*City of Florence*  
 Community Development Department  
 250 Highway 101  
 Florence, OR 97439  
 Phone: (541) 997 - 8237  
 Fax: (541) 997 - 4109  
[www.ci.florence.or.us](http://www.ci.florence.or.us)

This application is for final Planned Unit Development approval, for the project preliminarily approved by Resolution PC 22 21 PUD 01, PC 22 23 SUB 02, & SR 22 48 SIR 13.

This narrative addresses: (1) the conditions of preliminary approval and (2) FCC Title 10 Chapter 23 Planned Unit Development 10-23-11 Approval of the Final Development Plan.

ASSESSOR'S TAX MAP 18-12-22-11, TAX LOTS 200, 1100 AND 1200  
 FLORENCE, LANE COUNTY, OREGON  
 RESOLUTION PC 22 21 PUD 01, PC 22 23 SUB 02, & SR 22 48 SIR 13  
 AUGUST 2023

SITE MAP  
 1" = 40'

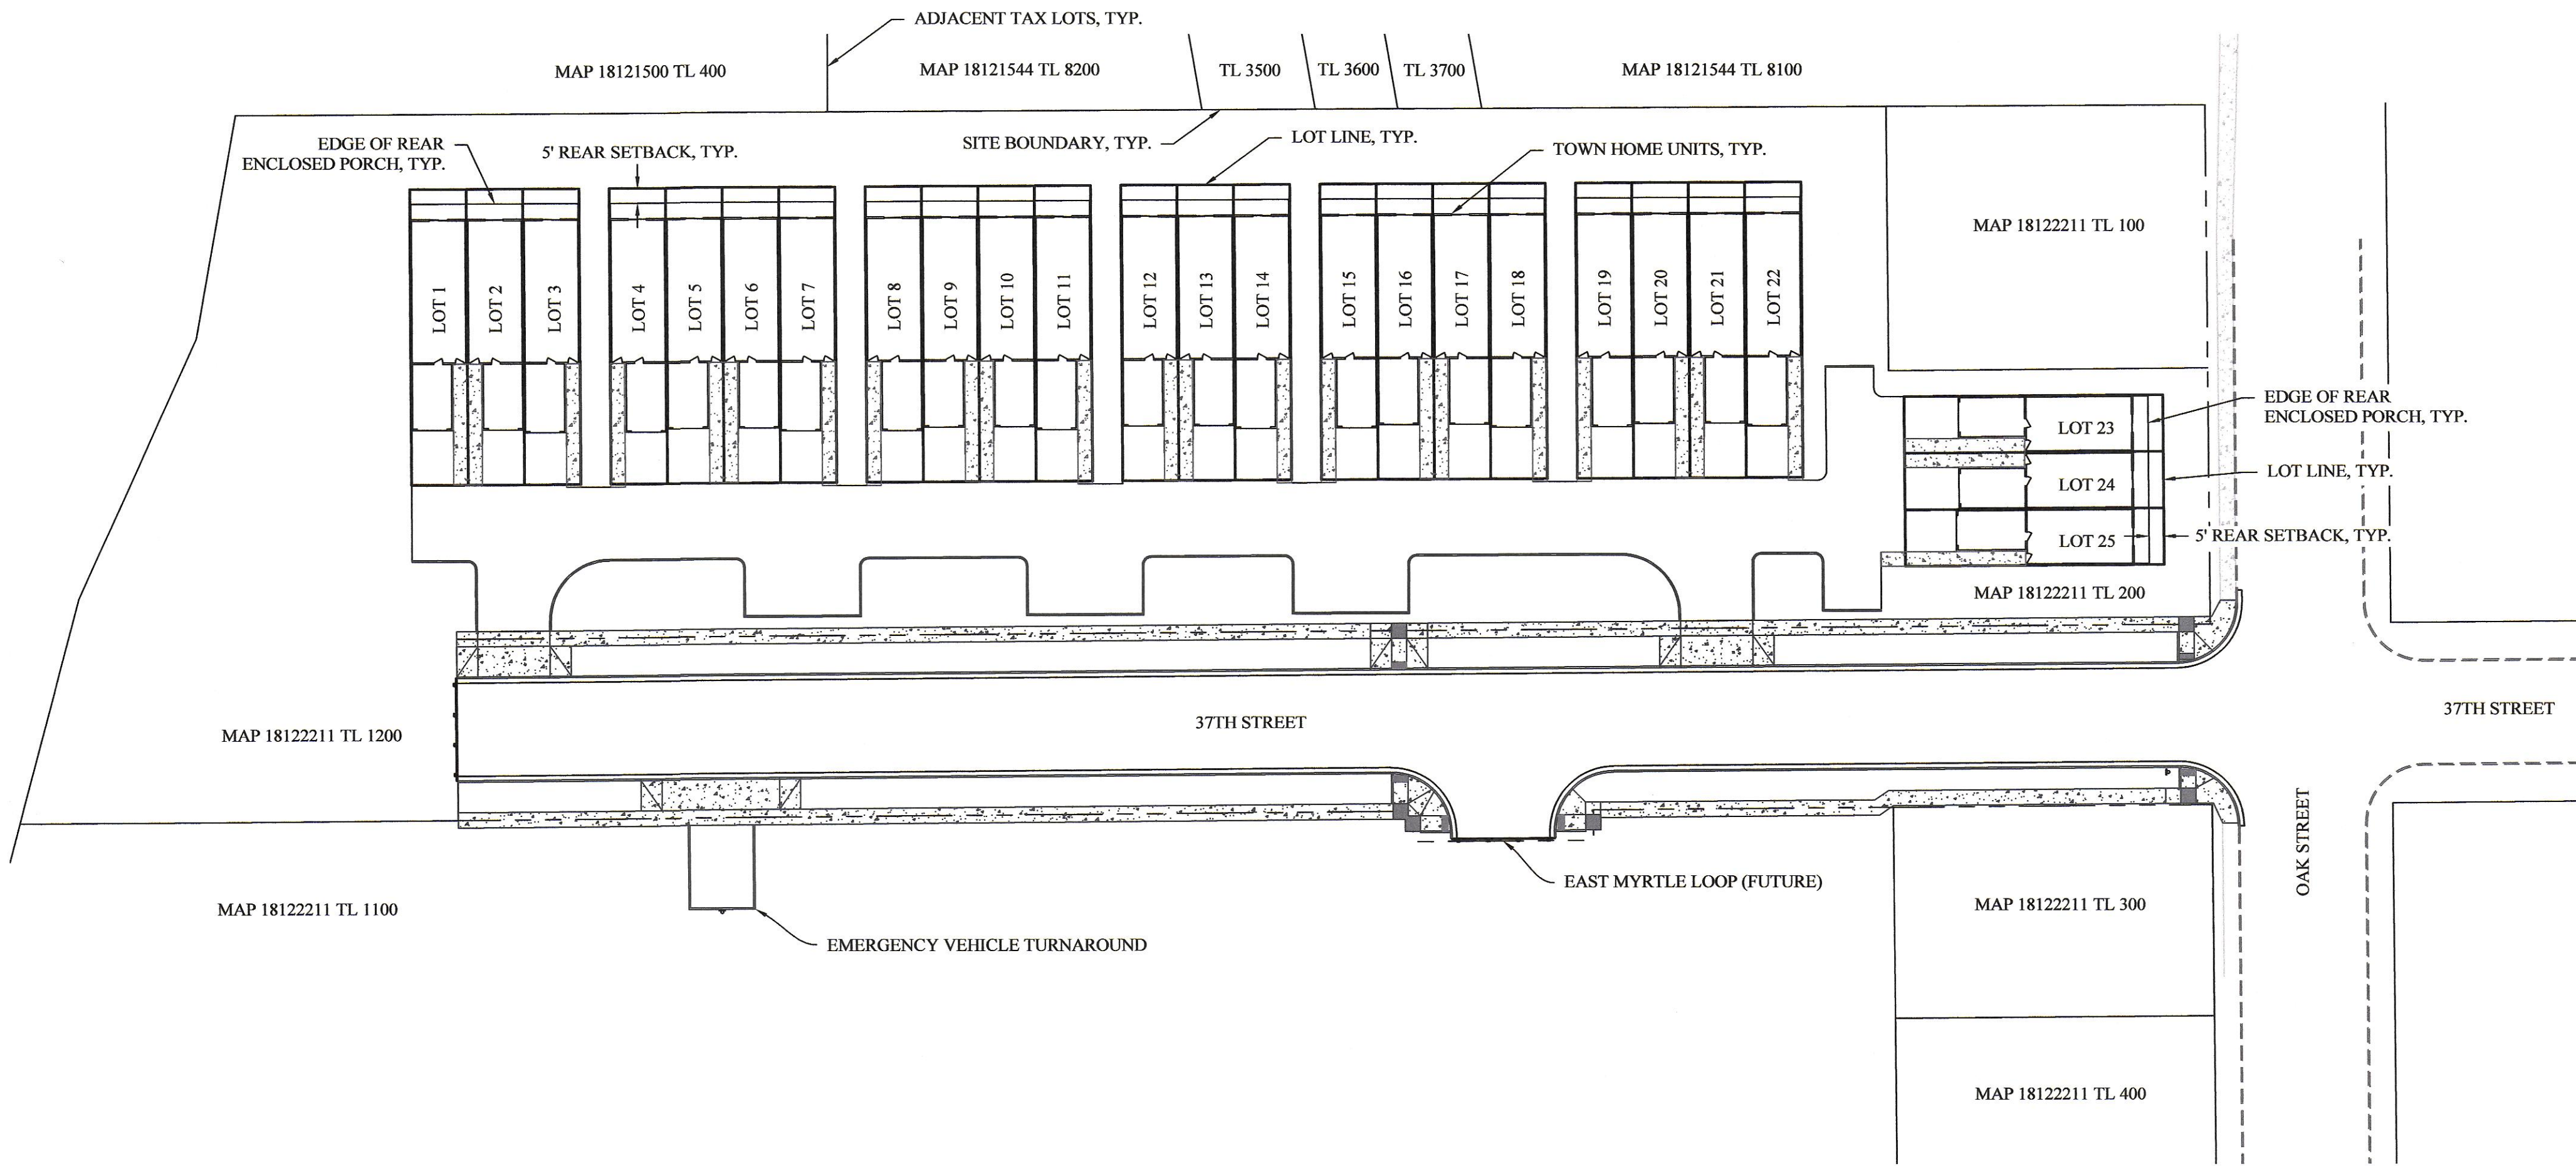
- Applicant narrative states this information is included on Attachment 1 Sheet G1 Cover.
  - Sheet G1 does not include dimensions of the rear yard setback.
    - Include dimension to demonstrate the rear yard setback has been met and Condition 6.2 has been satisfied.
- Applicant narrative states Attachment 2, Sheet S1 depicts the rear porch dimensions / protrusion.
  - Sheet S1 depicts the rear porch and provides dimension. However, the rear porch is not a rear yard setback. The sheet indicates a 3-foot-deep concrete landing and 11 ¼" step.
    - A rear lot line and evidence the 5-foot minimum setback is not satisfied with this image.

Attachment 1 Sheet G1 Cover Sheet (which is to scale) satisfies this condition. Attachment 2, Sheet S1 depicts additional information (plans for porch and concrete landing). The porches are proposed to be built up to rear setback line; the (uncovered) concrete landings are proposed to be built in the back yards.

**MYRTLE GLENN PUD**  
**FINAL PUD IMPROVEMENT DRAWINGS**  
**VEHICLE TURNAROUND PLAN**  
**AND DETAILS**  
**FLORENCE, OREGON**

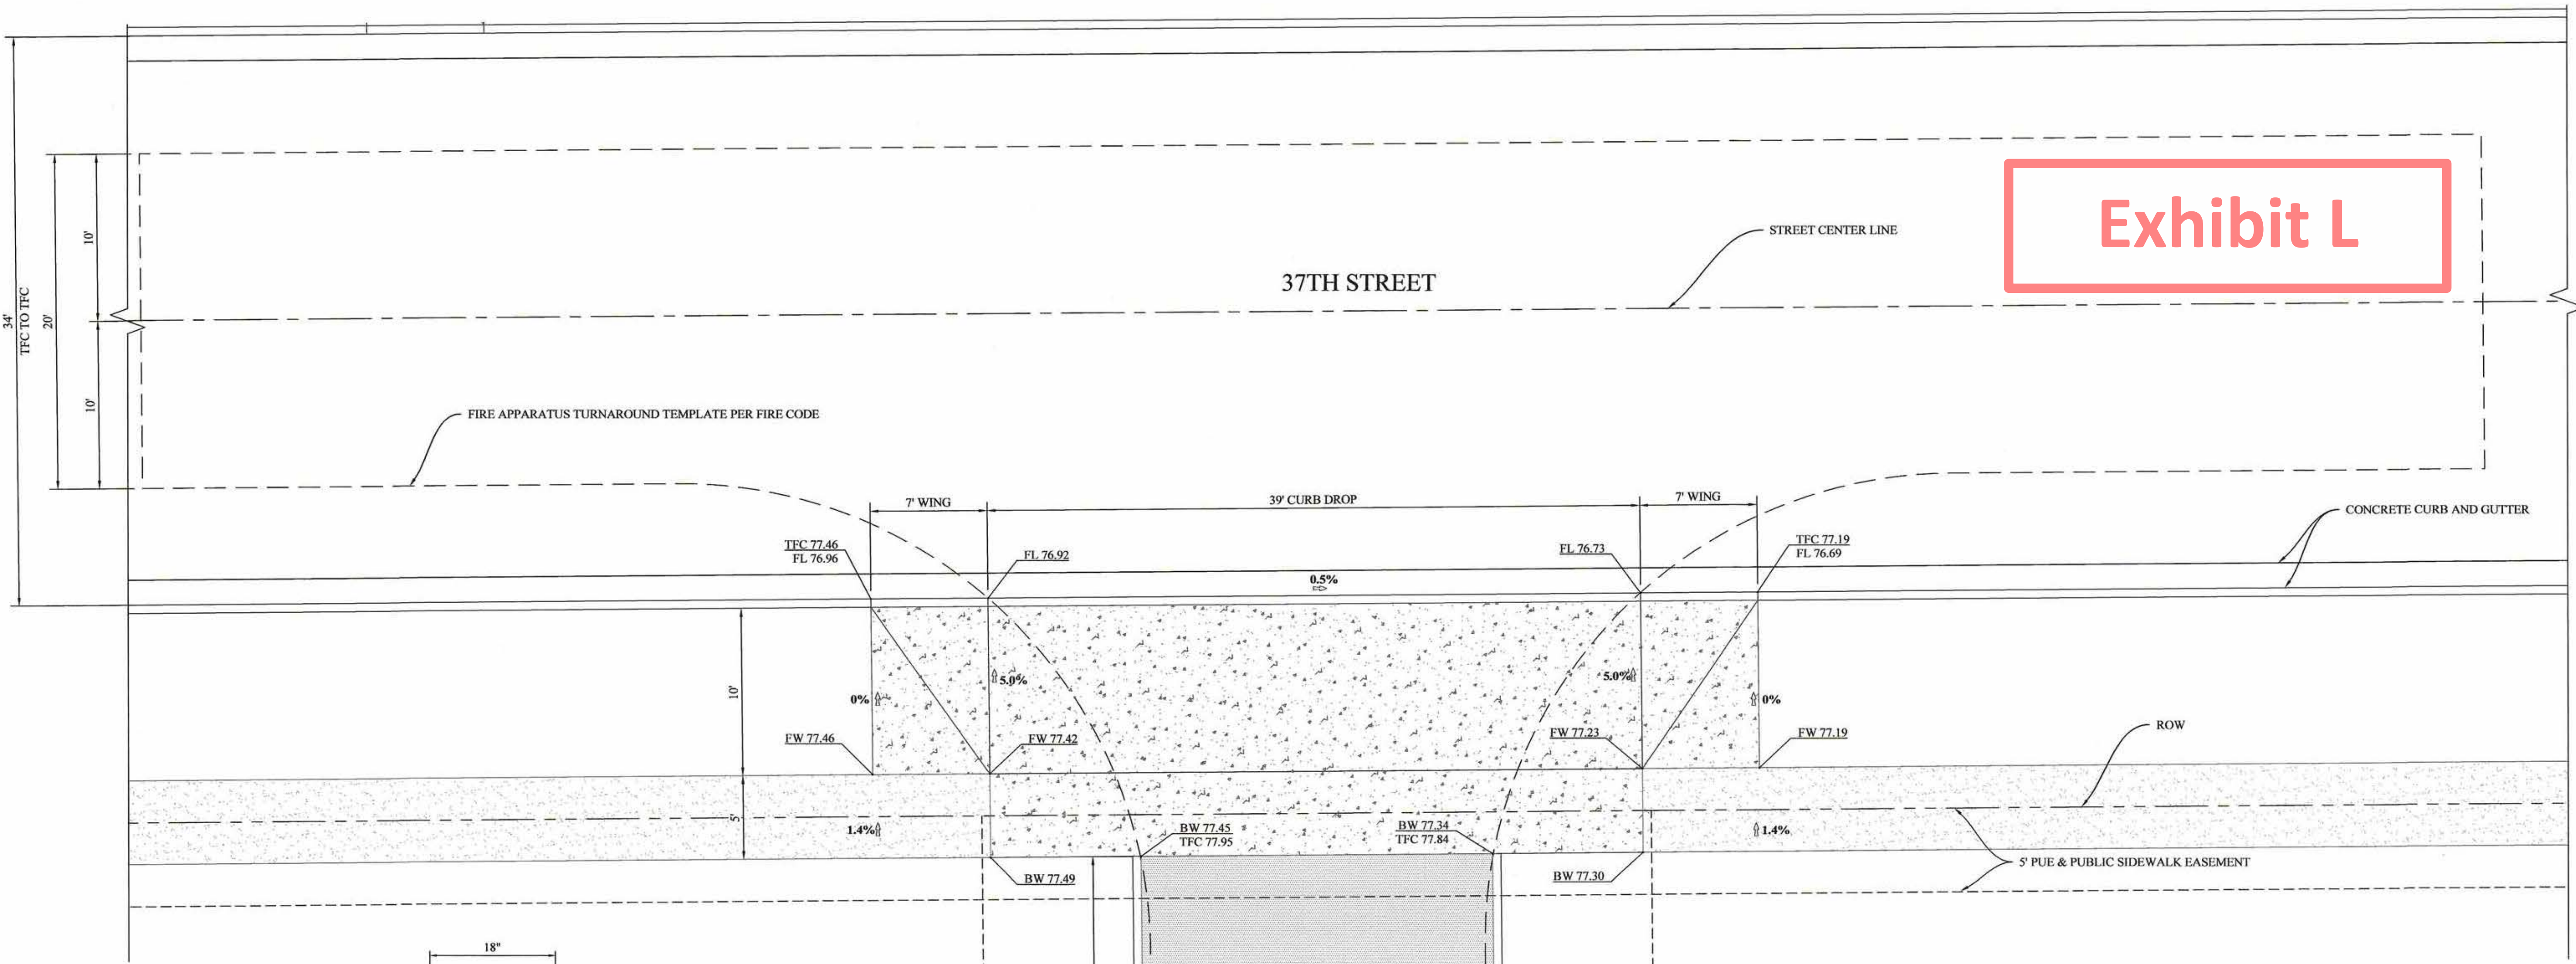
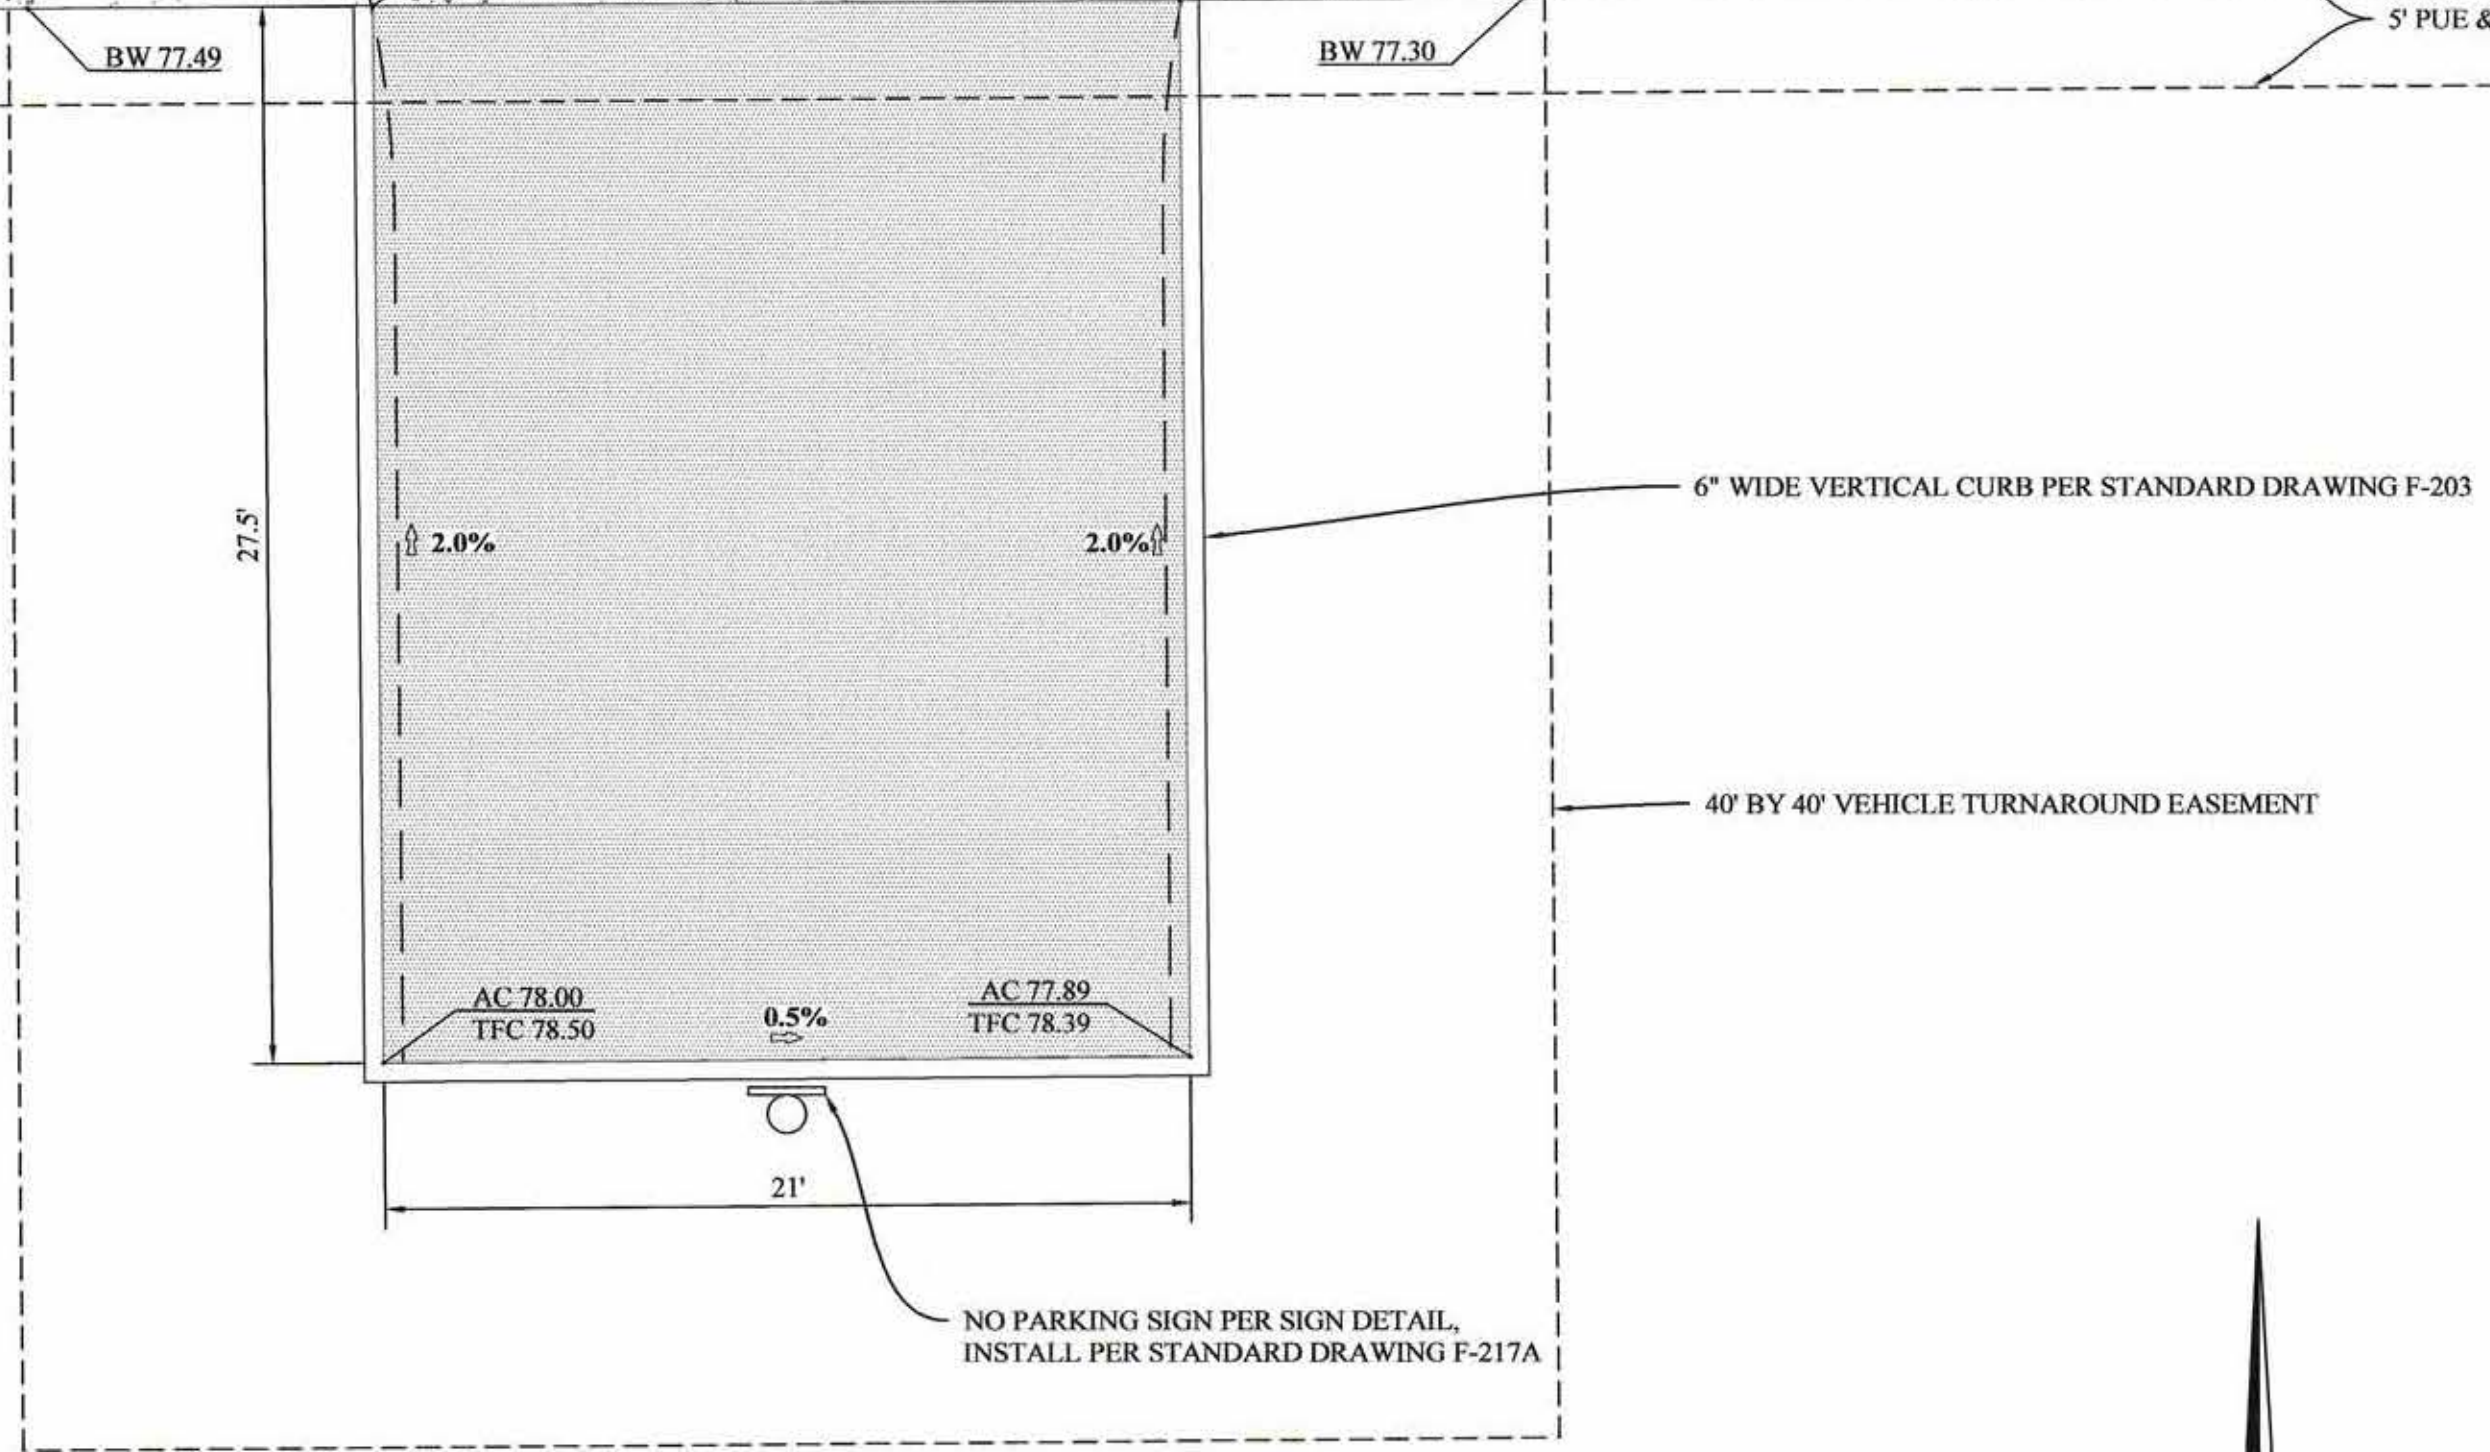
8.4 The applicant shall provide examples of signs to be installed at any and all fire access lanes or turnarounds in accordance with FCC 10-35-12-D section prior to issuance of building permits and all signs shall be installed and approved by public works prior to issuance of first Certificate of Occupancy. This is intended for fire apparatus and street signage in public ROWs. Condition 4.4 addressed parking signage on private property.

Attachment 1 Sheet C12 Vehicle Turnaround Plan satisfies this condition.
